RE: Bullitt East High School (25-145)
Change Order 3—Added inlets

Change Order

PROJECT: *(Name and address)*
BCPS Phase III - Bid Package No. 1 -
Bullitt EAST Physical Science Center

REQUEST FOR PROPOSAL

Revised Drawings BEHS PSC: C1.32, C1.33

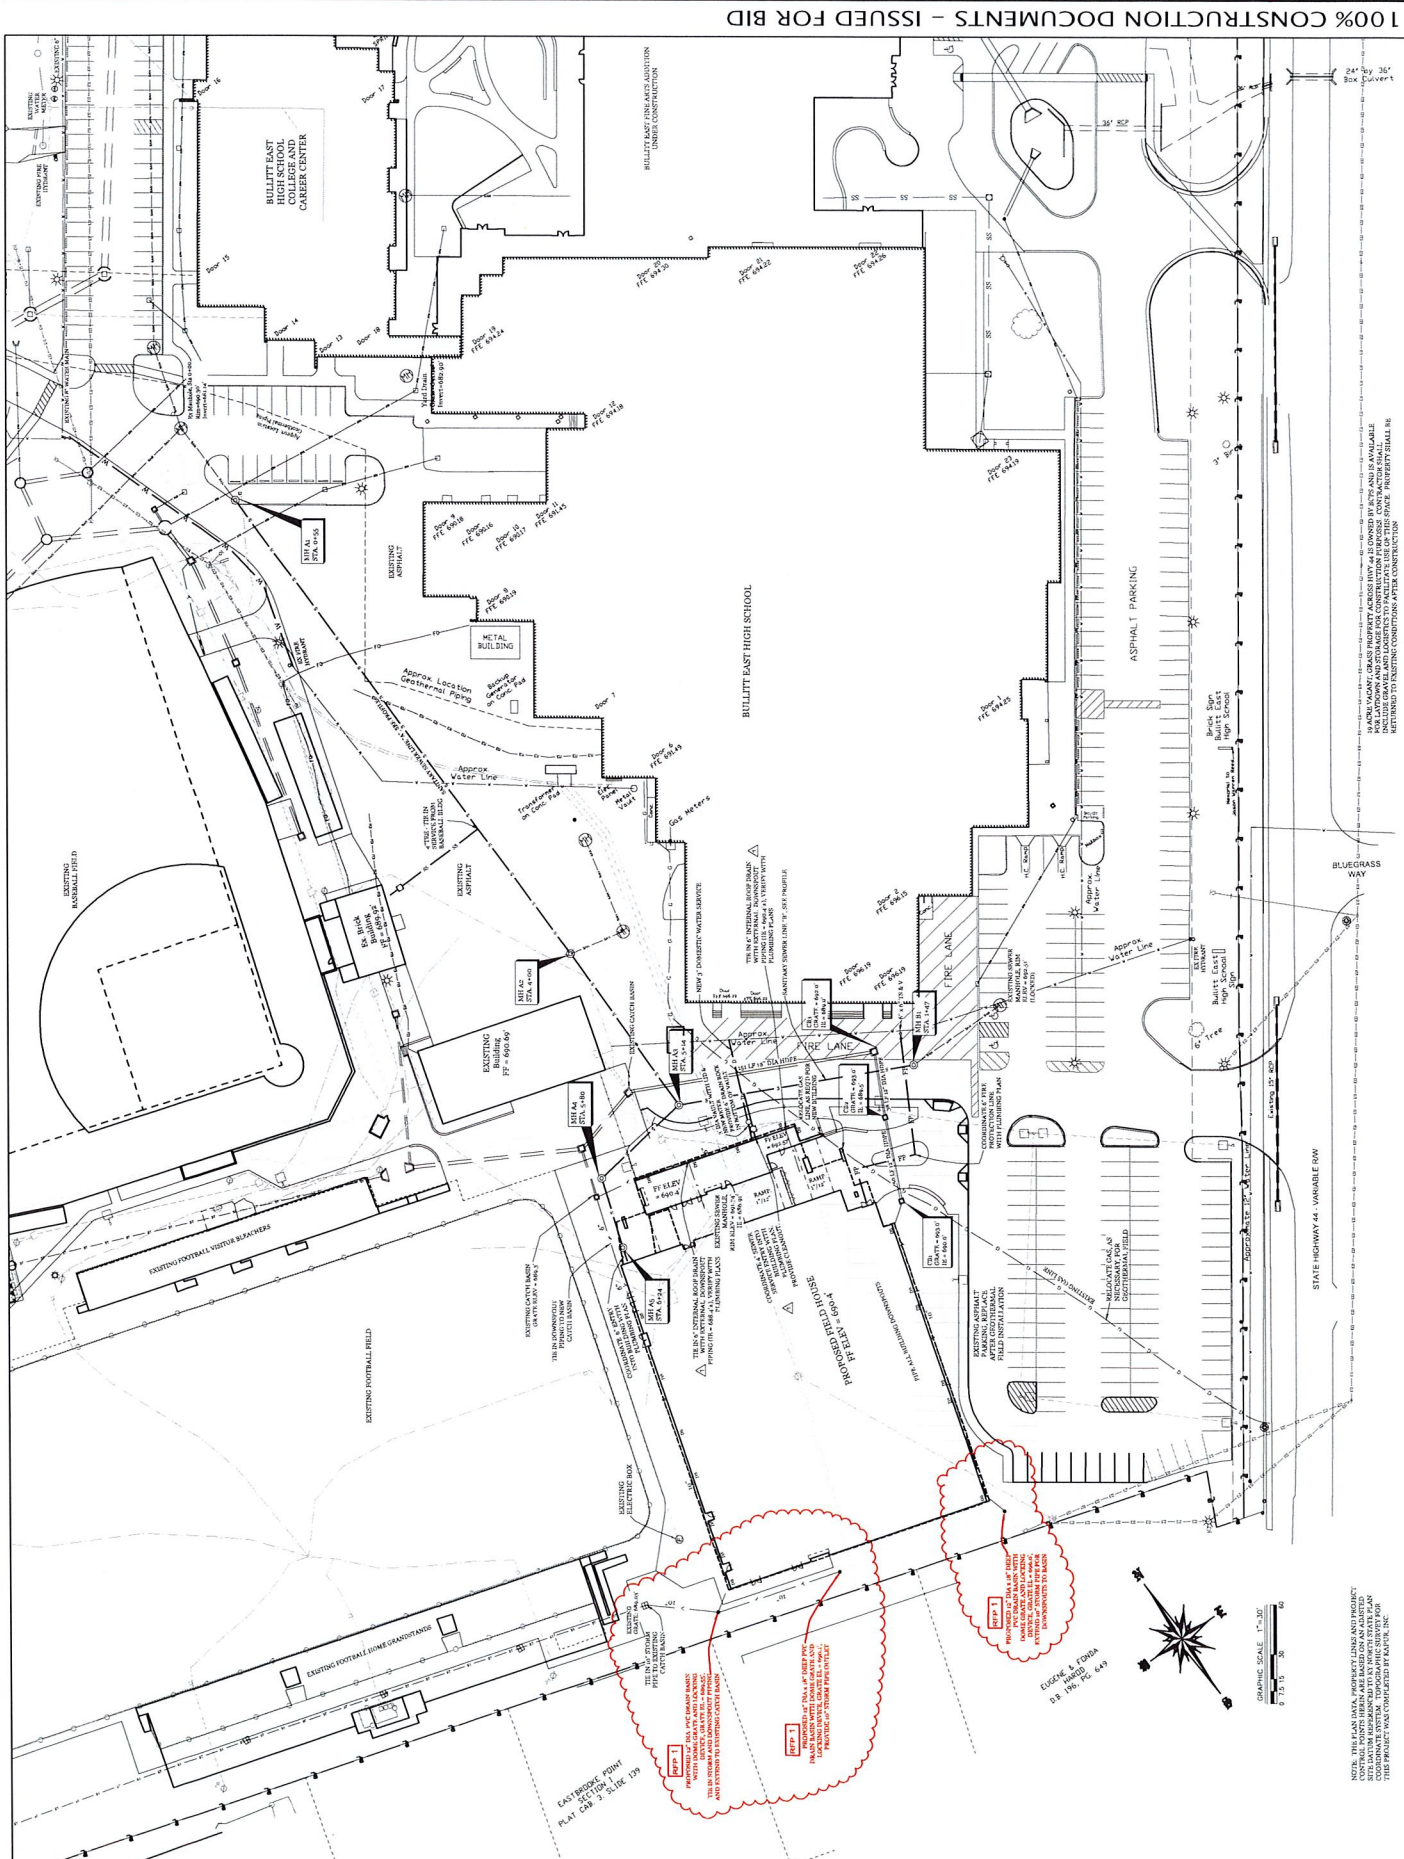
- Item No.1** Refer to BEHS PSC - C1.32:
- Additional surface inlets proposed along the southwest side of building.
- Item No.2** Refer to BEHS PSC - C1.33:
- Grading adjustments shown at proposed surface inlets along the southwest side of building.
